Fwd: Revised Mixed-Use Project at 8150 W. Sunset Bl - DOT Letter

8150 W. Sunset Bl
DOT Case No. CEN 16-44691

Subject: **UPDATED TRANSPORTATION ANALYSIS FOR THE PROPOSED MIXED-USE PROJECT LOCATED AT 8150 WEST SUNSET BOULEVARD**

CONCEPTUAL INTERSECTION IMPROVEMENTS
SUNSET BOULEVARD AND
CRESCENT HEIGHTS BOULEVARD

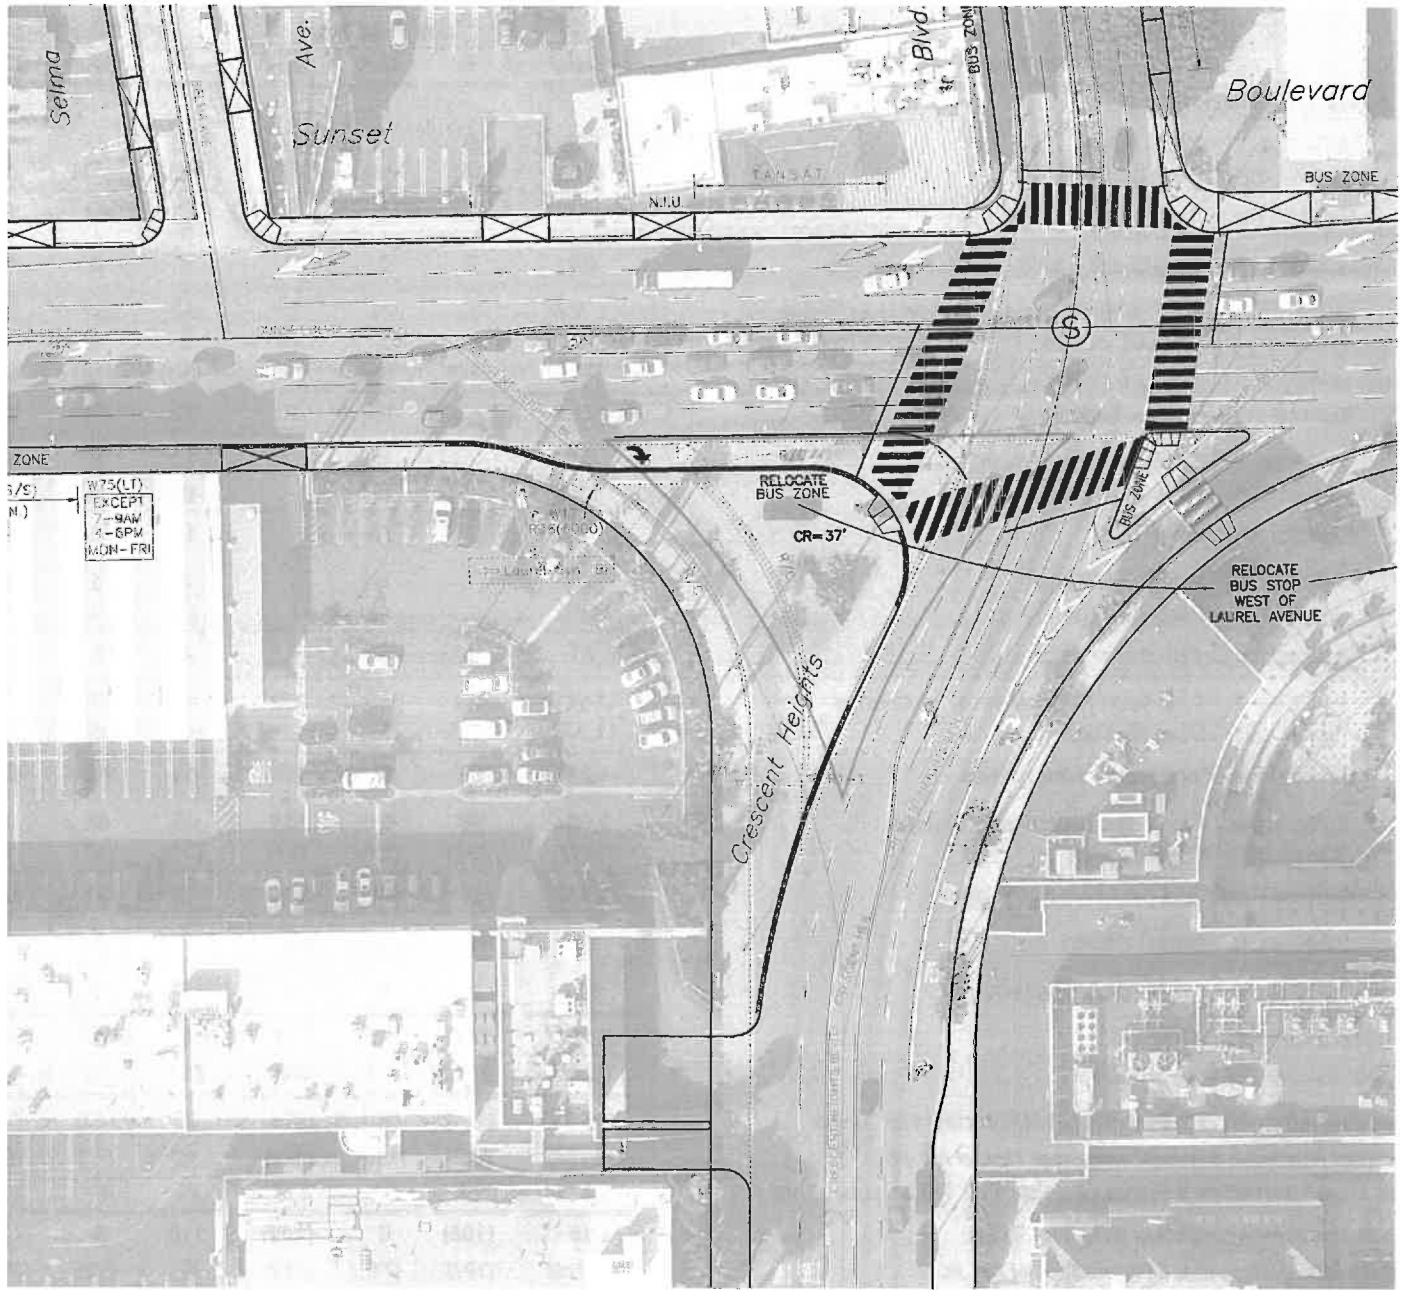
To enhance and activate the pedestrian environment adjacent to the project, the project proposes to reconfigure the southwest quadrant of the intersection of Sunset Boulevard and Crescent Heights Boulevard. The improvement would remove the current sweeping eastbound right-turn lane on Sunset Boulevard that is stop-controlled before merging with southbound Crescent Heights Boulevard, and install a typical exclusive right-turn lane at the intersection. The unused "triangle" section would then be reconfigured to provide a new public "plaza" area adjacent to the northeast corner of the project site as illustrated in **Attachment 3**.

To accommodate the exclusive eastbound right-turn lane, the south side of Sunset Boulevard would be widened and the west side of Crescent Heights Boulevard between Sunset Boulevard and the project's driveway would be reconstructed. Conceptually, this improvement is acceptable to DOT; however, to ensure optimal efficiency and safety of the intersection's operations for all modes, the existing bus stop on the eastbound approach should be relocated from the near-side and the traffic signal may need to be upgraded to install northbound left-turn phasing and concurrent eastbound right-turn phasing (subject to review by DOT's Hollywood/Wilshire District Office). These design issues should be discussed with DOT and Council District 4 prior to the commencement of the engineering plans for this improvement.

This section of Sunset Boulevard has been identified as a roadway within the High Injury Network (HIN), which spotlights streets with a high concentration of traffic collisions that result in severe injuries and deaths, with an emphasis on those involving people walking and bicycling. The proposed improvement would result in enhanced safety by removing the sweeping eastbound right-turn lane, thus eliminating a pedestrian-vehicle conflict point.

Attachment 4 8150 W. Sunset Bl

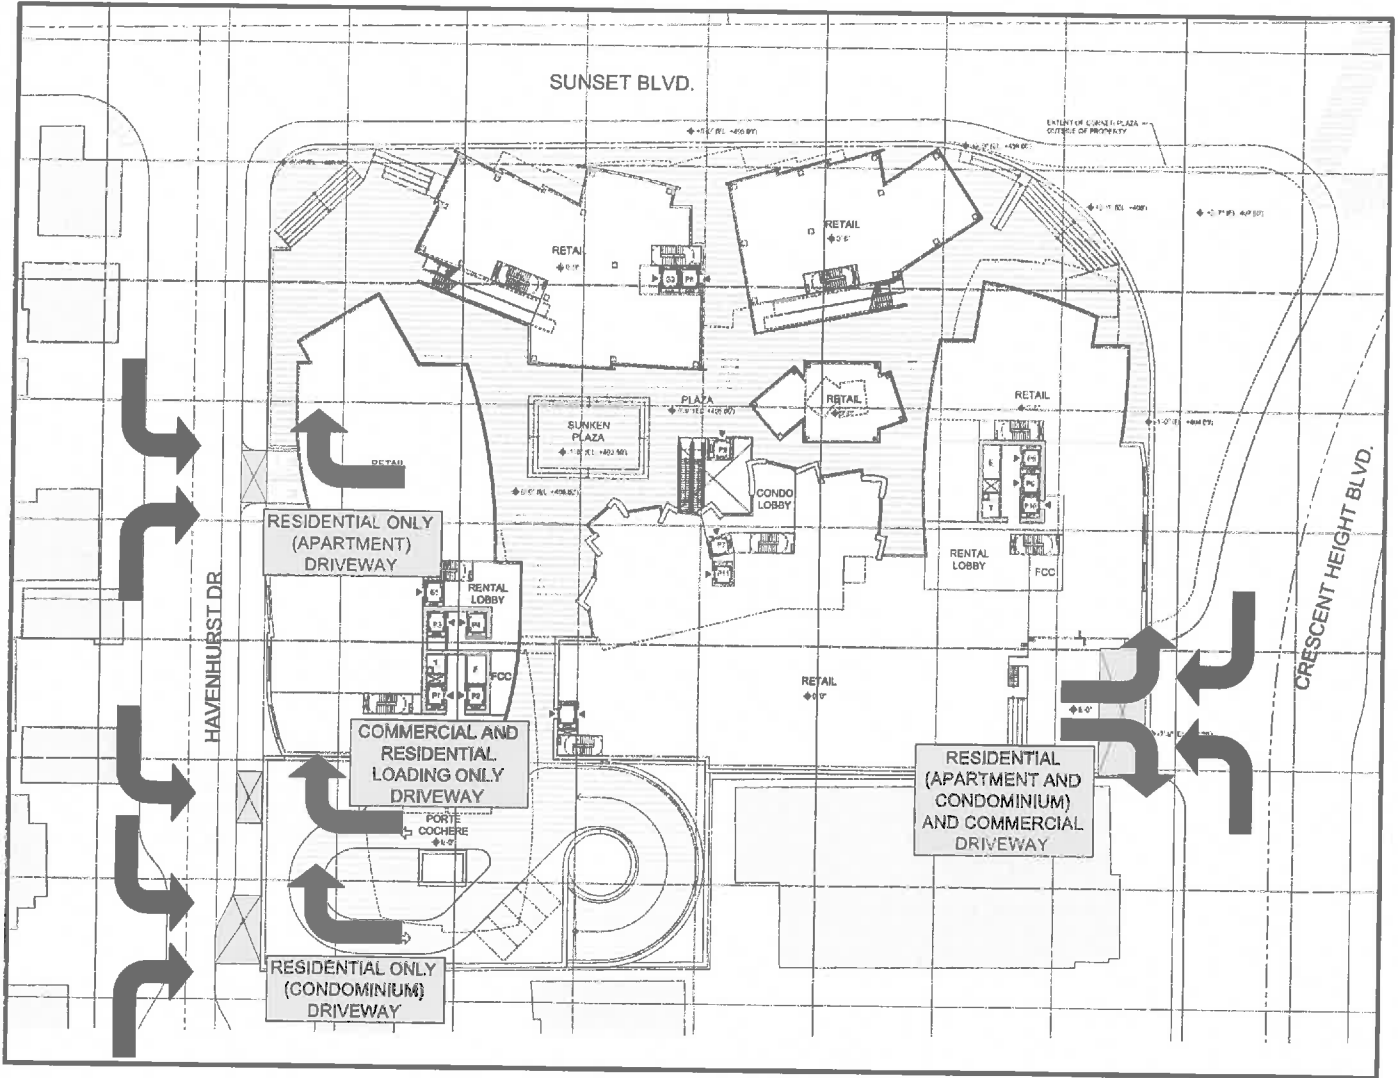
The proposed project will provide vehicular access via three driveways: a driveway on Crescent Heights Boulevard (two-way full access) and two on Havenhurst Drive (both full service entry only driveways and right-turn only exit) as illustrated in **Attachment 4**. If the voluntary intersection improvement is not completed at Crescent Heights Boulevard and Sunset Boulevard, then driveway on Crescent Heights Boulevard should be restricted to right-turn ingress/egress only. The analysis studied this scenario and it did not change the results. Truck access to the on-site loading dock facilities is provided on Havenhurst Drive. The project also proposes a passenger pick-up/drop-off loading area onsite via the project driveways.

Review of the study does not constitute approval of the driveway dimensions and internal circulation schemes. Those require separate review and approval and should be coordinated with DOT's Citywide Planning Coordination Section (201 N. Figueroa Street, 4th Floor, Station 3, @ 213-482-7024). In order to minimize potential building design changes, the applicant should contact DOT for driveway width and internal circulation requirements so that such traffic flow considerations

are designed and incorporated early into the building and parking layout plans. All new driveways should be Case 2 driveways and any security gates should be a minimum 20 feet from the property line. All truck loading and unloading should take place on site with no vehicles backing into the project via any of the project driveways.
